LANDSCAPE &
PUBLIC REALM
GARRARD STREET TREES NMA2
STATIONHILL SOUTH SITE
(PHASE 1)

3.1 NMA APPLICATION AREA

3.1.1. Plan of consented and re-designed areas

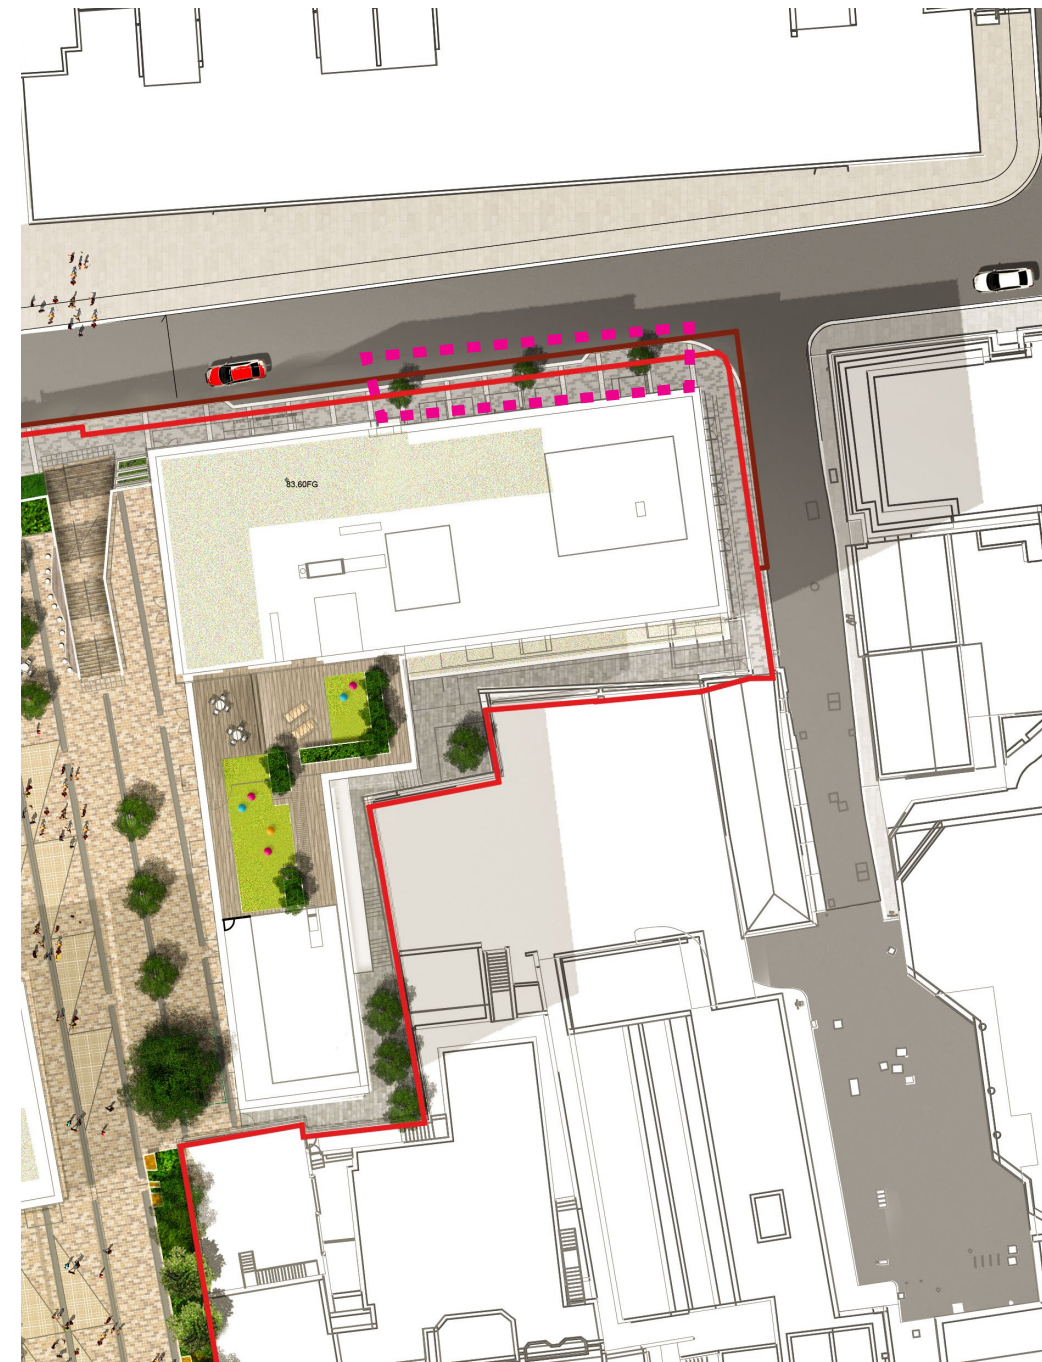
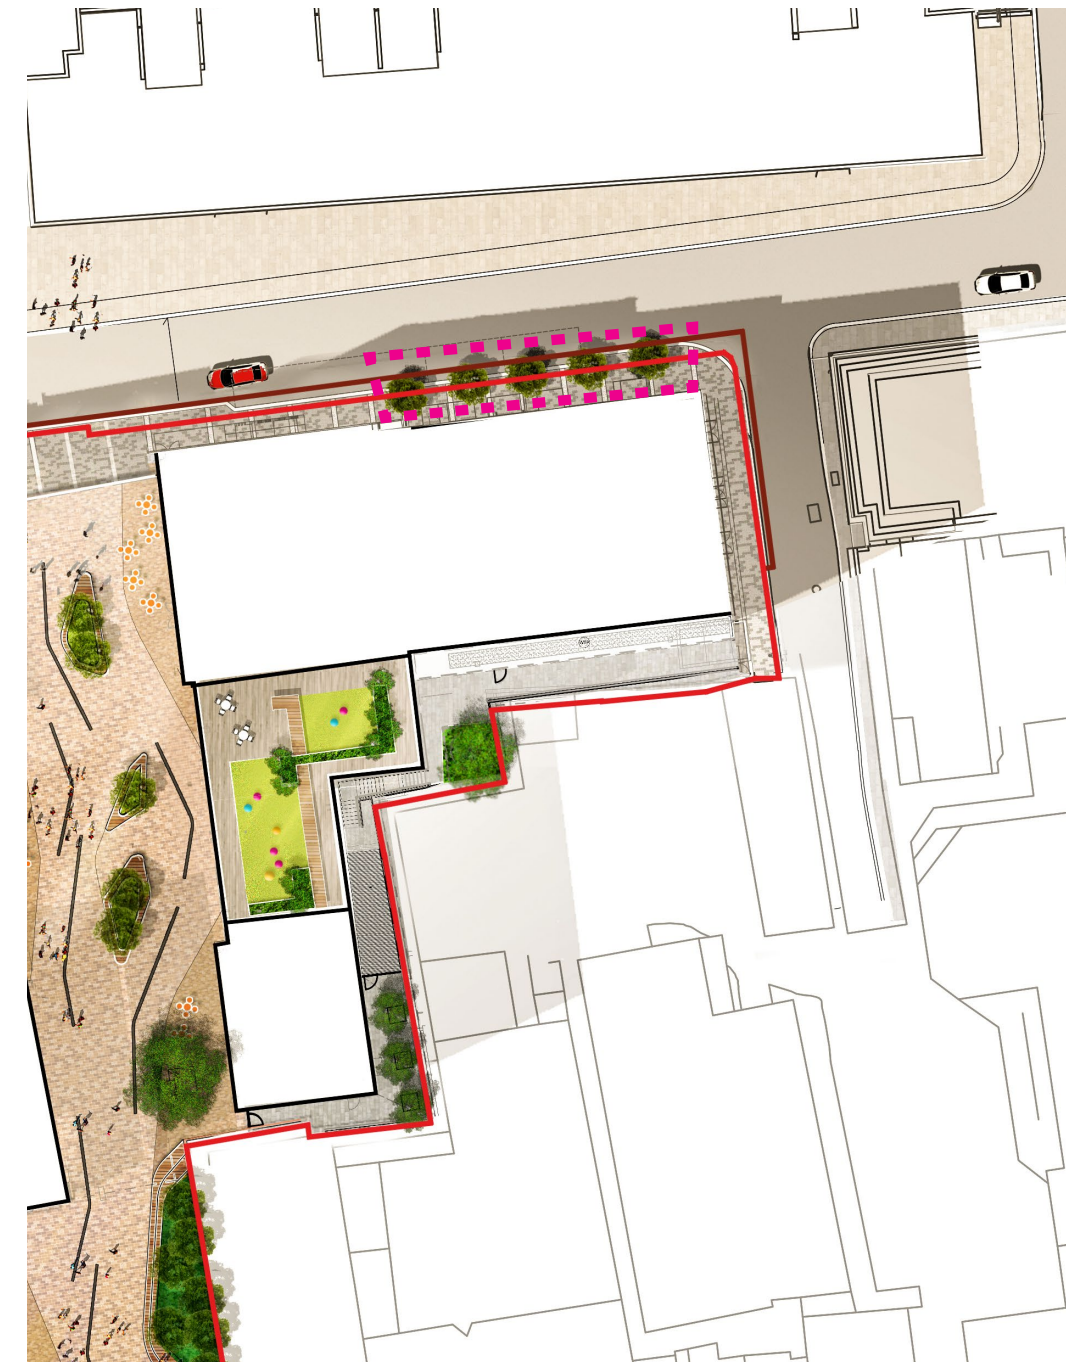
This non-material change application is for the addition of 2 trees to Garrard Street (required as wind mitigation for phase 2), the area within the original application boundary is outlined in the plan opposite.

As well as an additional two trees to Garrard Street, the tree species of all five trees in pots has been amended from *Sorbus acuparia* to *Sorbus incana* following consultation with the local tree warden.
